Safety Evaluation Report

Related to the License Renewal of Prairie Island Nuclear Generating Plant Units 1 and 2

Docket Nos. 50-282 and 50-306

October 2009

Figure 4.3-1

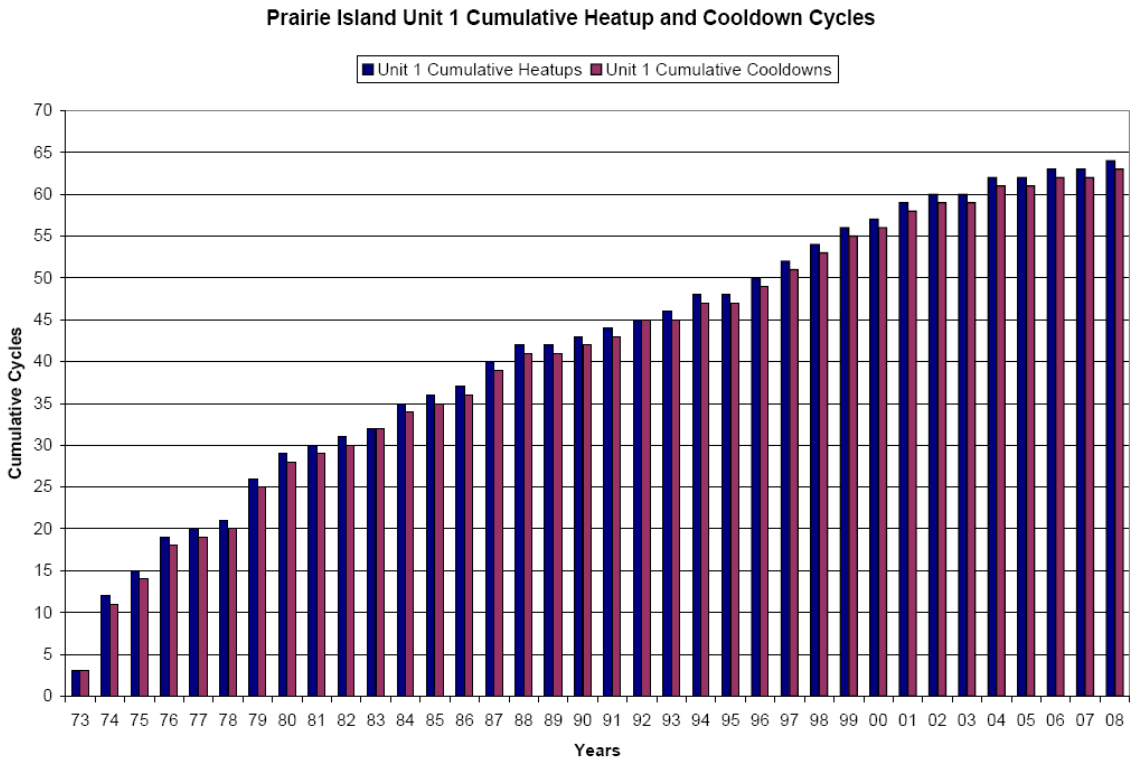
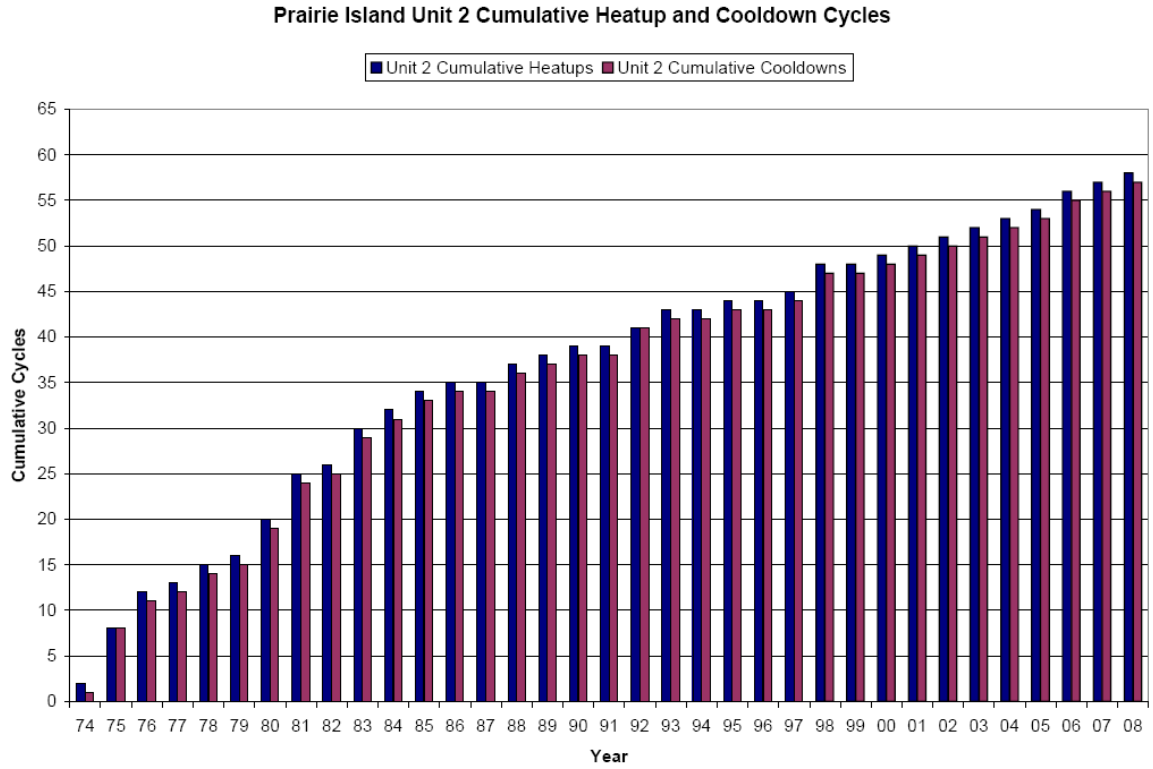
The staff reviewed these histograms and found that the transient occurrence rates (both heatup and cooldown) are quite constant for Unit 1 since 1980 and for Unit 2 since 1983. This means that for the past 25 years, the PINGP (Units 1 and 2) plant operation has been quite steady. The applicant made its cycle projections by doubling the actual number of cycles accrued as of September 30, 2006, using the maximum from either unit. The staff notes that cycle projection can be graphically represented, based on Figure 4.3-1 by drawing a straight line from the intersection of the x and y axes to the 2003 data point, boosted to the cycle value accrued by September 30, 2006, using the maximum from either unit. It is clear from Figures 4.3-1 and 4.3-2, that the slope used by the applicant for making cycle projections is significantly greater than that of the average of the past 25 years. As expected, the slopes of event occurrence (i.e., the rates) during the first few years (5 to 7 years) are higher than the averages for both heatups and cooldowns. This means that the basis of projections that the applicant used is conservative and therefore, the staff found it to be acceptable.

Based on its review, the staff's concern on the transient event monitoring is resolved because the applicant provided the information requested and the information validates the PINGP fatigue management program and the applicant's assumption for the number and severity of transients.
